AGENDA
BUDGET & FINANCE COMMITTEE MEETING
Tuesday, September 14, 2021 at 7:00 p.m.
N168 W20733 Main Street
Jackson, WI 53037

SECTION 00 63 63
CHANGE ORDER

Change Order No. 10

SDD 09E07 Traffic Signal Standard Pedestrian and Flasher Typical Mounting Details

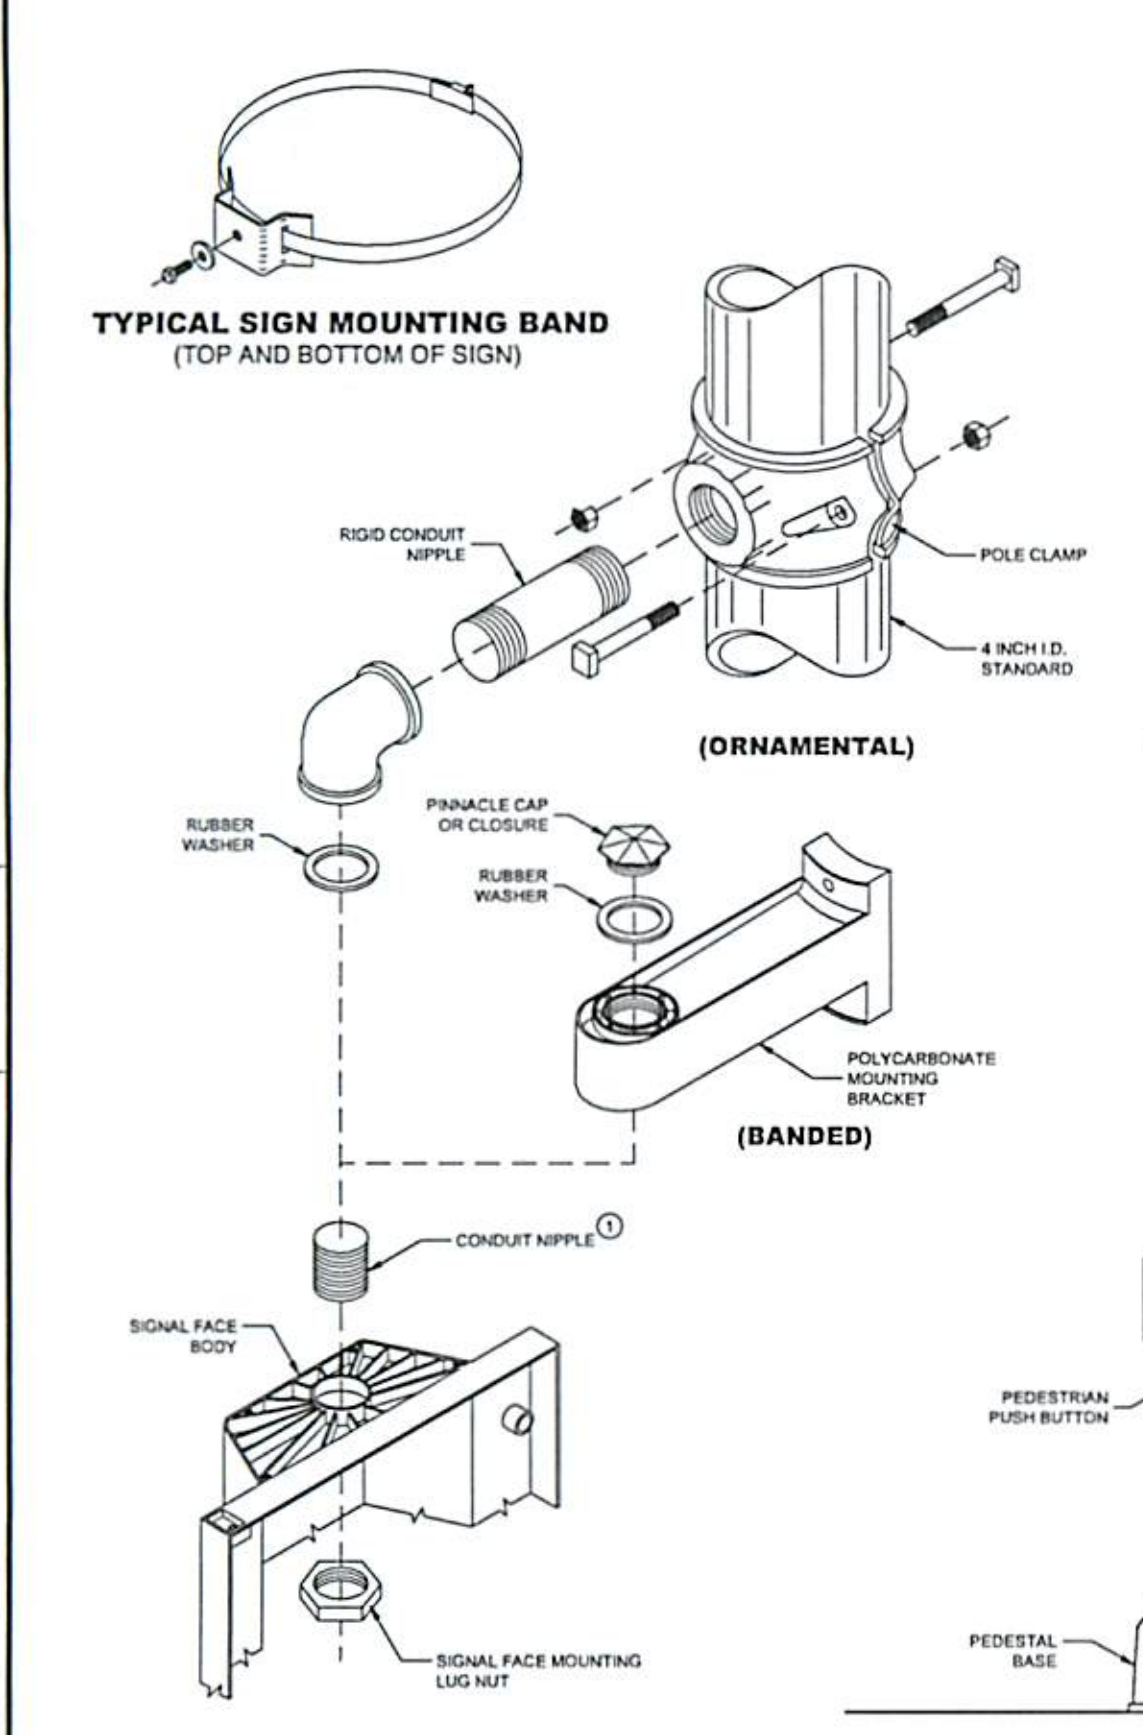
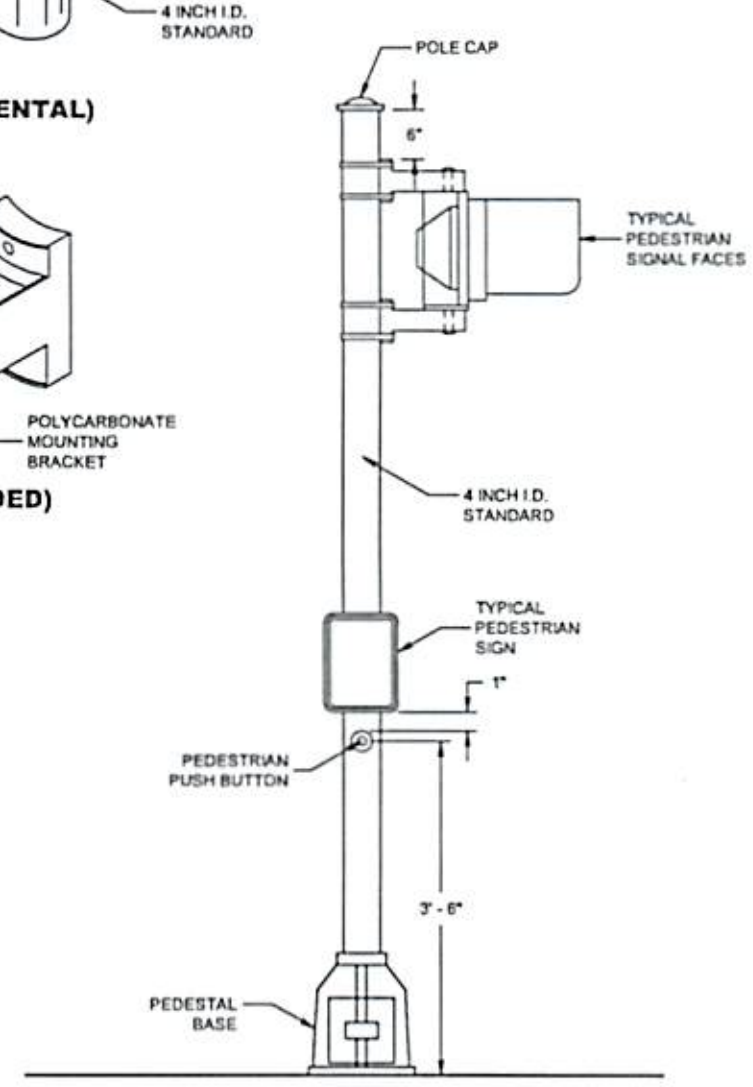
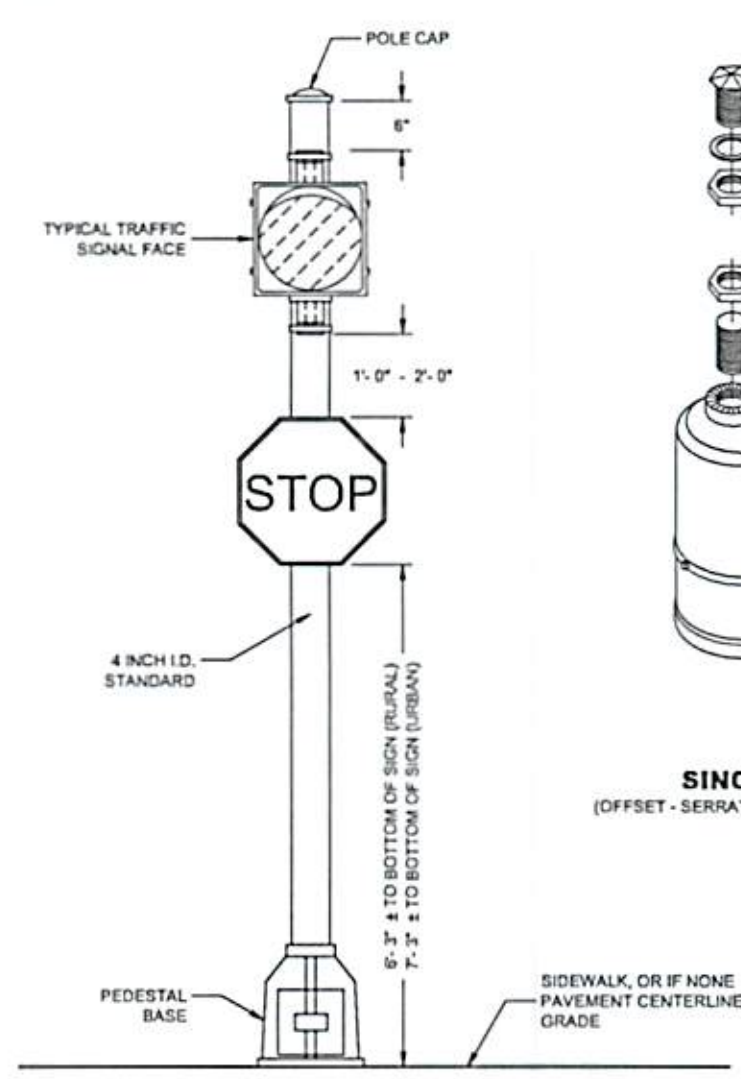
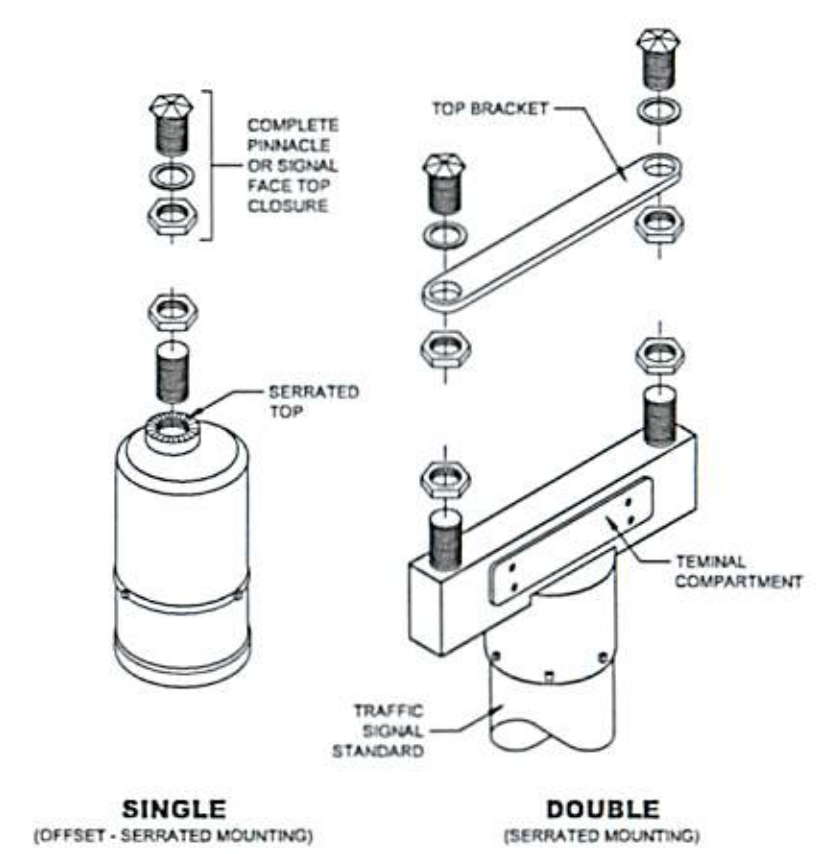
a) Change Order Item No.1: Owner’s staff decided to facilitate the purchase of the Traffic Alert System proposed within STH 60 outside of the Municipal Complex contract. Owner’s staff coordinated a system more specific to the Fire Department’s needs including compatibility with their current pre-emptive system as well as the inclusion of a service and maintenance aspect. Therefore, the traffic alert system included within the Municipal Complex contract is deleted.

FRONT OFFICE ELEVATION 4
NTS

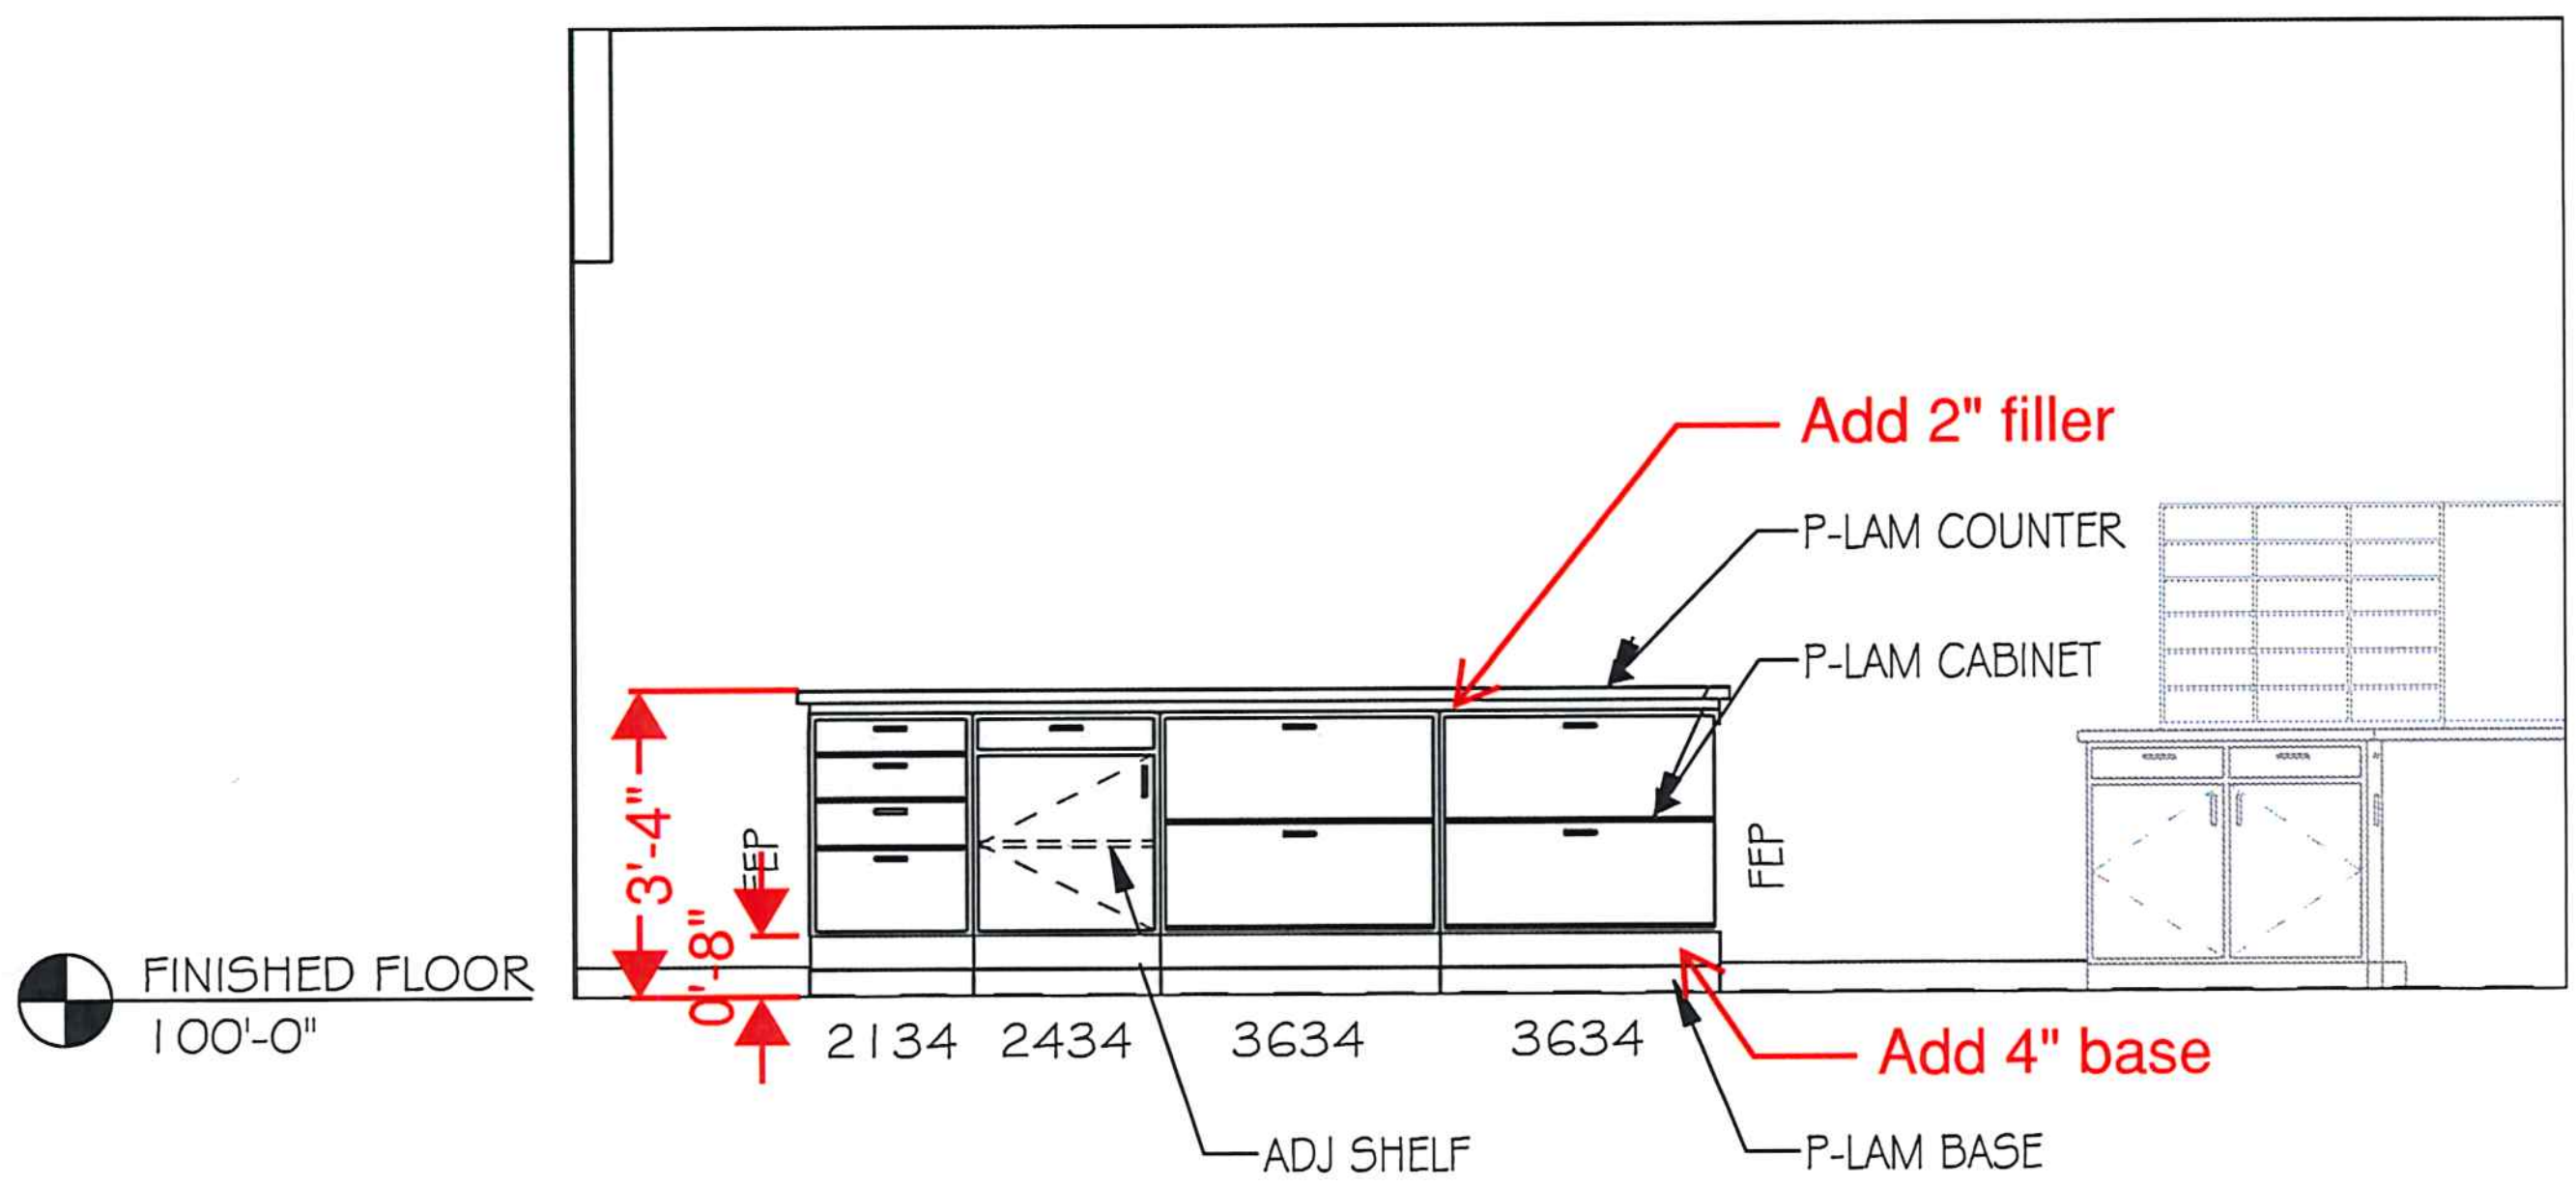
Owner's staff requested the adjustment in planned height to island cabinetry section located within the Police Department's Front Office area (Room 1B12). Planned cabinetry height = 34", Adjusted cabinetry height = 40"

Attached is a revision the PD would like to see some pricing on to increase the cabinet base and add a filler just below the counter to raise the counter height to 3'-4". Please, provide a cost proposal for this revision.

- Raise toe kicks and provide filler just below countertop to raise counter height to 3'-4" $2,180.00
- Modify electrical components already installed $375.00
